Delaware Basin Changes to APD for Federal Well

| SD WE 14 FED P7 #3H | API#: 30-025-43086 |

Summary of Changes to APD Submission

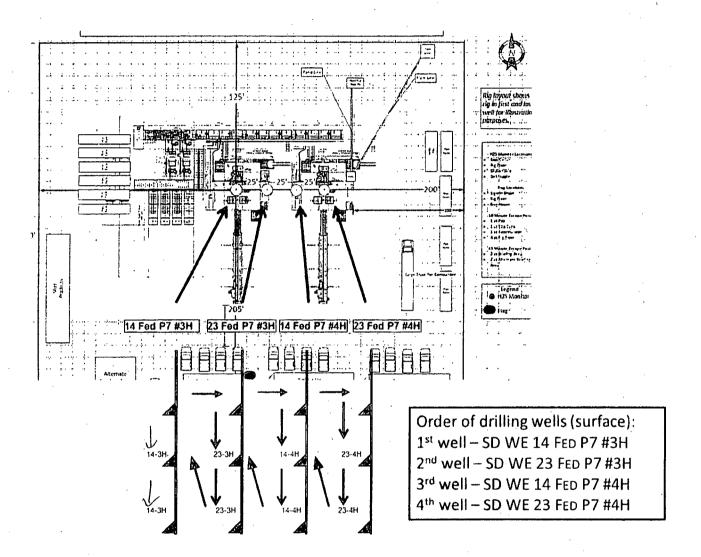
- 1. Drill 17-1/2" surface hole with fresh water to planned casing set depth with 10' rat hole.
- 2. Run casing as stated by approved APD, land out wellhead, and cement.
- 3. Dress out 13-5/8" 5M SH-2 wellhead and install/secure with temporary abandonment cap, and a pressure gauge will be installed. Reference image below.
- 4. Skid to next well according to below "Drill Order"

| As Defined in APD: | As Planned on Well: |
|---|---|
| Section 3 – Chevron Request a variance to use a GE/Vetco SH-2 Multibowl Well Head | Chevron Request a variance to use a FMC UH2 Multibowl Well Head |
